**Re: PART 573 NOTICE RE MCI G4500 TAG AXLE SWING ARM RECALL PLAN**

AMENDED December 21, 2006

# Service Bulletin No.212

<b>MODEL</b> G4500 Series Coaches	<b>TYPE</b> Field Change Program	<b>SECTION/GROUP</b> 2B - Trailing Axle	<b>DATE</b> Dec. 04, 2003
<b>SUBJECT</b> TAG AXLE WELD REWORK			
<b>CONDITIONS</b>

**Figure 4.**

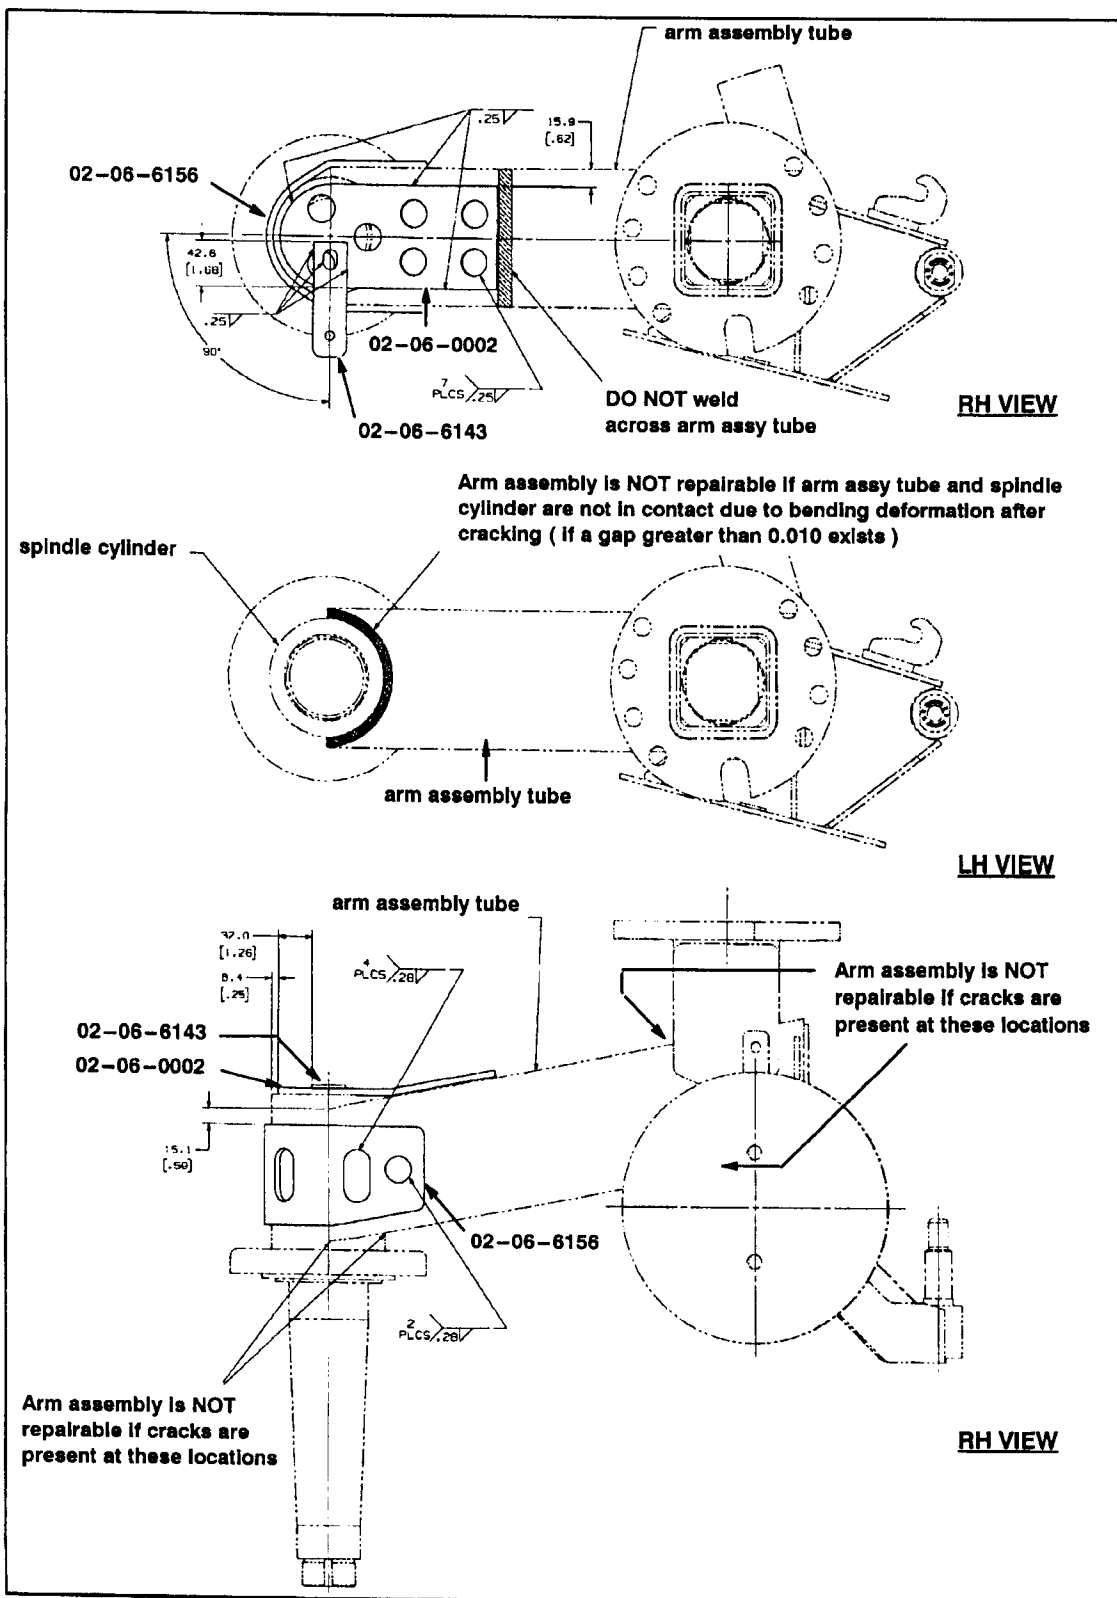
- A. Cracks propagate thru the arm assembly tube.*
- B. Cracks are present at lower wheel spindle end of the arm assembly ( Figure 4 ).*
- C. Arm assembly tube and spindle cylinder are not in contact due to bending deformation after cracks are initiated ( if cracks are more than 0.010 inch ) ( Figure 4 ).*

13. Position the plate ( part number 02-06-0002 ), ensuring that it sits flush and in full contact with the arm tube and spindle ( Figure 4 ).
14. Remove any sharp burrs on the inside edge of the hole in the plate ( part number 02-06-0002 ).

15. Position the plate ( part number 02-06-0002 ) and strap ( part number 02-06-6156 ) in place, ensuring proper fit and installation ( Figure 4 ). Using clamps, secure the plate and strap in position.

16. Preheat the entire assembly to 400 degrees F. Use a temperature stick to verify that proper preheat temperature has been achieved.
17. Weld around inside edge of hole using SMAW process and E7018-1 electrodes ( Figure 4 ).

20. Weld the strap and reweld the brake hose bracket ( removed in Step 12. ), according to welding symbols in Figure 4. DO NOT weld across arm assembly.

**Figure 5. Re-worked tag axle arm.**

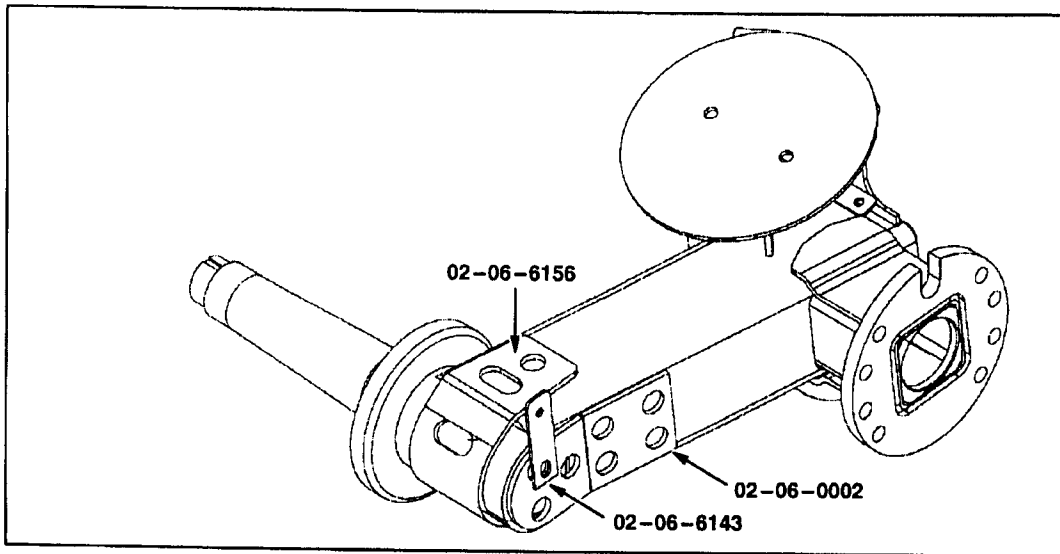
MCI has made design changes to improve the durability and reliability of the tag axle installation. As a result, MCI advises that all G model coaches between the range of unit numbers 80026 to 80518 implement the specified steps in this procedure.

**Figure 9. Re-worked tag axle arm.**

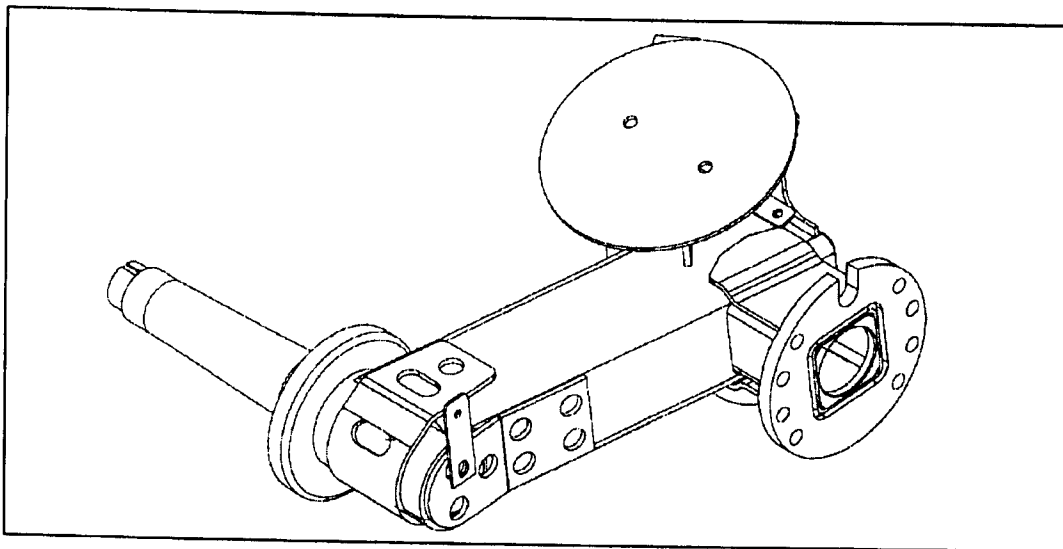
16. Remove the air spring from the existing tag arm assembly. Install the air spring on the re-worked tag arm assembly ( part number 02-06-0001 / 02-06-0003 ).

Figure 10.

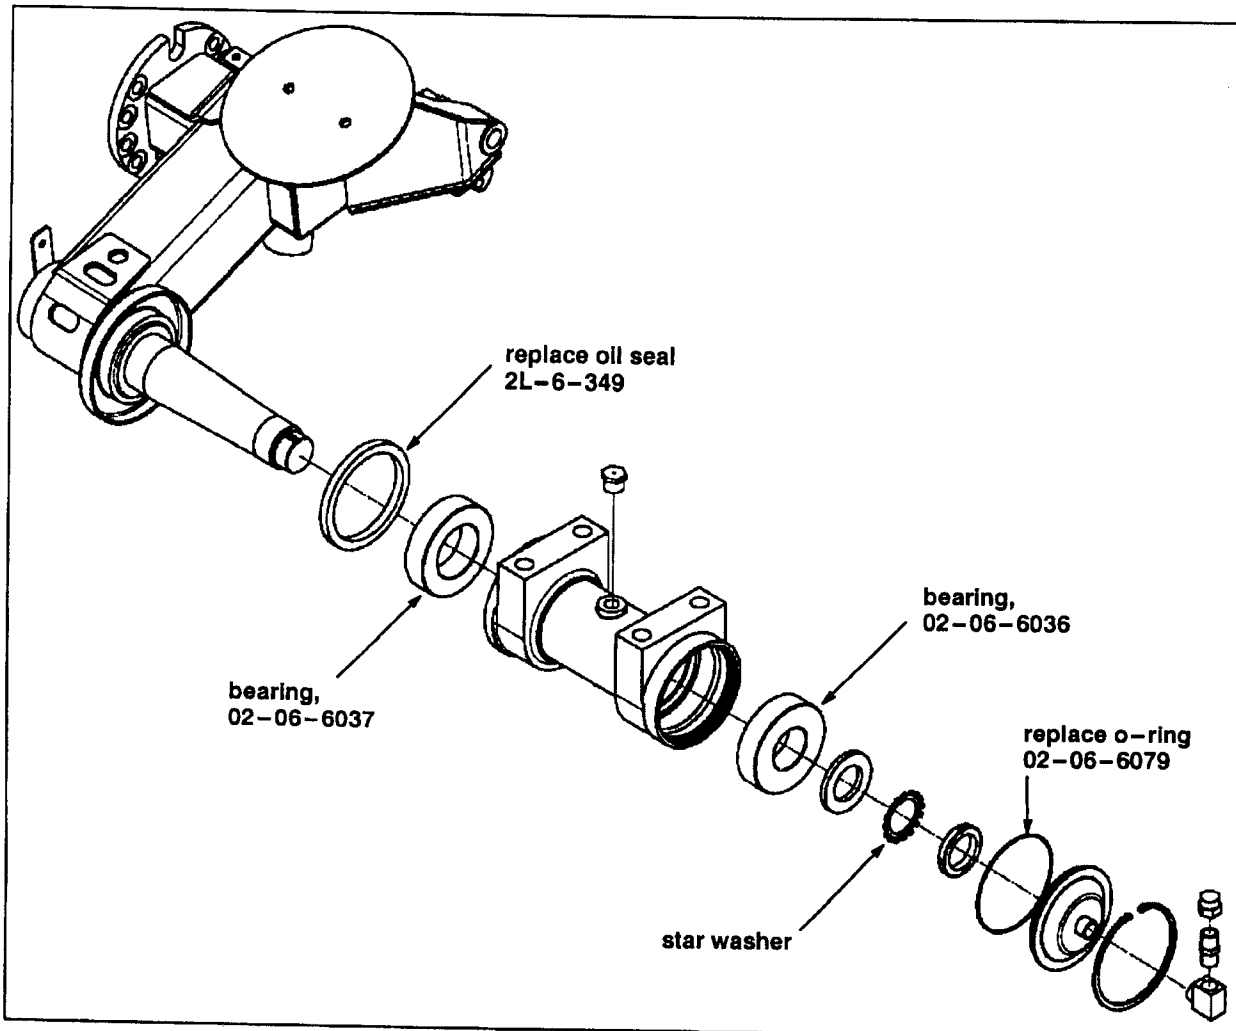
*Replace the oil seal ( part number 2L-6-349 ), o-ring ( part number 02-06-6079 ) and bearing box lubricant after every disassembly ( Figure 10 ).*

20. Install bearing box assembly onto the re-worked tag arm assy, taking care to ensure that the seal is not damaged. Install "outer" bearing, flat washer, star washer, and lock nut ( Figure 10 ). Torque the nut to 95 – 105 lb–ft. while rotating the bearings on the arm. Back off, and re-torque to 29 – 32 lb–ft., while again rotating the bearings on the arm. Bend a tab from the star washer into one of the notches in the nut. Replace o–ring ( part number 02-06-6079 ) and install end cap and snap ring ( Figure 10 ).

**Figure 12. Trailing Axle Shim Installation.**

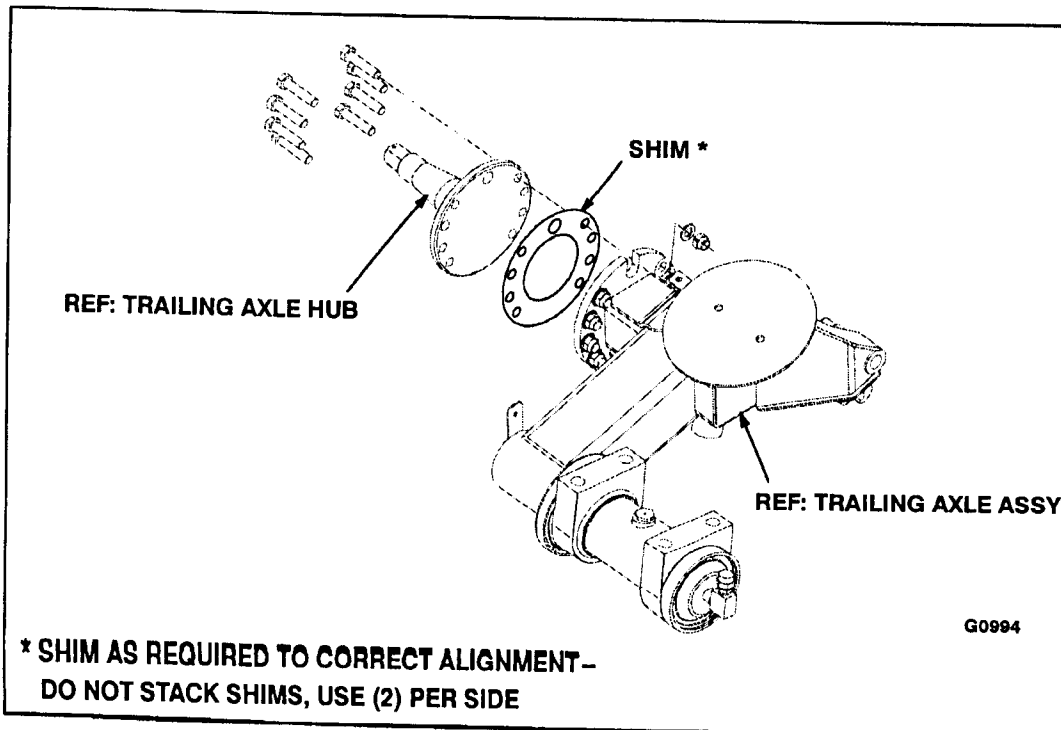
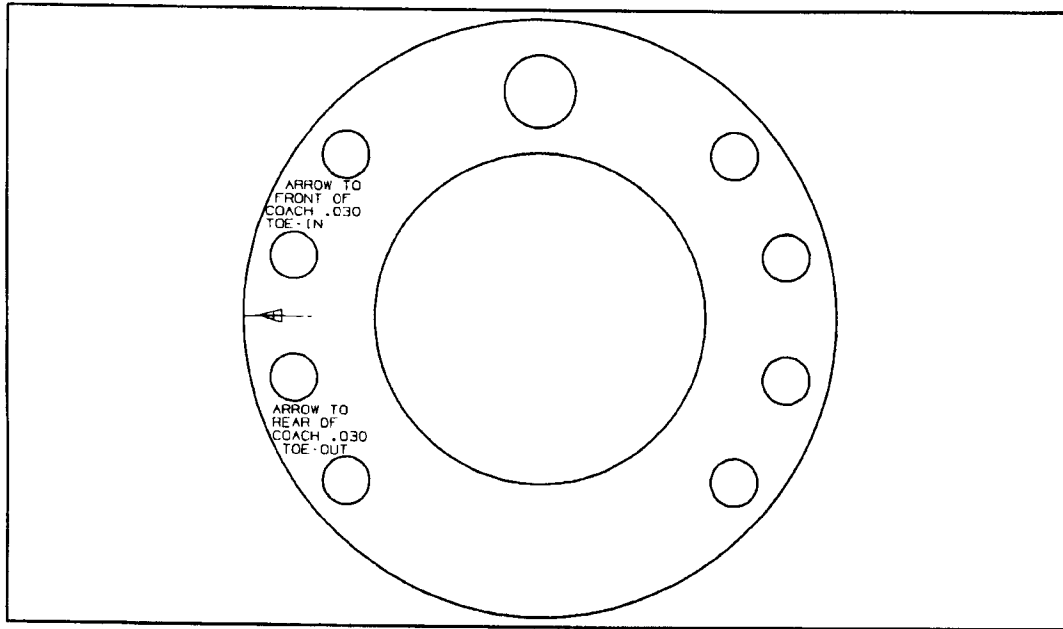
If the toe measurement is out of specification less than 0.62" per side, adjust the wheel end using shims. Install only one of these shims per side of the vehicle (Figure 12). Disassemble tag wheel end and install shim between swing arm and wheel spindle. Reassemble wheel end. Torque all components to the proper torque value and verify alignment is within specifications. Fill the hub with oil.

**Only 2 shims allowed per side.**
